# Access Compliance Report

## Public Rights-of-Way

Intersection ID: 14553	Main Street: BRIAR_CREEK_RD	Cross Street: MONROE_RD	Location: NW
ADA ID: 566FE23D3AD1	Ramp Type: PerpDiag	Initial Pass/Fail: Fail	Overall Compliance: No
Severity Score: 22.5			
Codes/Mitigation Info/Possible Solution		Field Measurements/Component Compliance

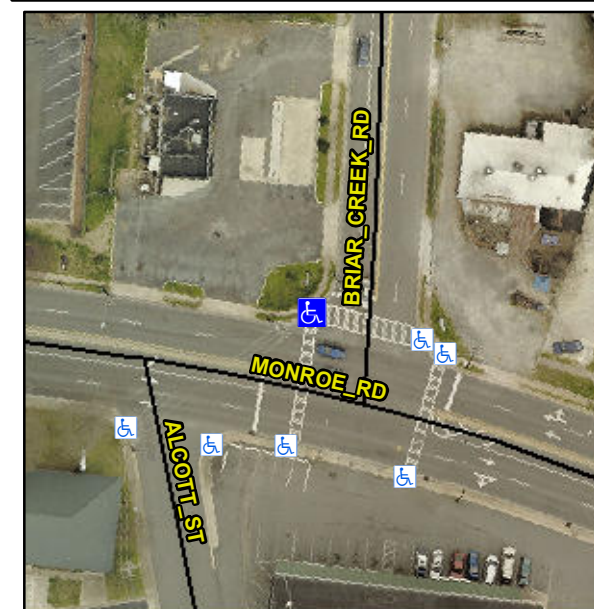
**Not Found, R304.5.1, R304.2.2, R304.5.3**

Compliance	Description	Data	Compliance	Description	Data
N/A	Ramp Length (in)	60.0	No	Ramp Slope (%)	9.8
No	Ramp Width (in)	47.0	No	Ramp XSlope (%)	2.4
N/A	Flare Type LT	N/A	N/A	Flare Type RT	N/A
N/A	Flare Slope LT (%)	N/A	N/A	Flare Slope RT (%)	N/A
N/A	Flare Traversable LT?	N/A	N/A	Flare Traversable RT?	N/A
N/A	Landing Length (in)	N/A	N/A	DWS Provided?	N/A
N/A	Landing Width (in)	N/A	N/A	DWS Contrast?	N/A
N/A	Landing Slope (%)	N/A	N/A	DWS Length (in)	N/A
N/A	Landing X Slope (%)	N/A	N/A	DWS Full Width?	N/A
N/A	Landing Curb? (Y/N)	N/A	N/A	DWS Offset (in)	N/A
N/A	Shared Landing?	N/A			
N/A	Gutter Ponding?	N/A	N/A	Gutter Slope (%)	N/A
N/A	Gutter Lip Ht (in)	N/A	N/A	Gutter X Slope (%)	N/A
N/A	Painted X Walk1?	Yes	N/A	Painted X Walk2?	Yes
	X Walk 1 Direction	To SW		X Walk 2 Direction	To SE
N/A	X Walk 1 Width (in)	56.0	N/A	X Walk 2 Width (in)	113.0
	X Walk 1 Slope (%)	1.6		X Walk 2 Slope (%)	0.6
	X Walk 1 X Slope (%)	1.0		X Walk 2 X Slope (%)	1.2

**Remove & Replace Curb Ramp With Two New Directional Ramps or Equivalent.**
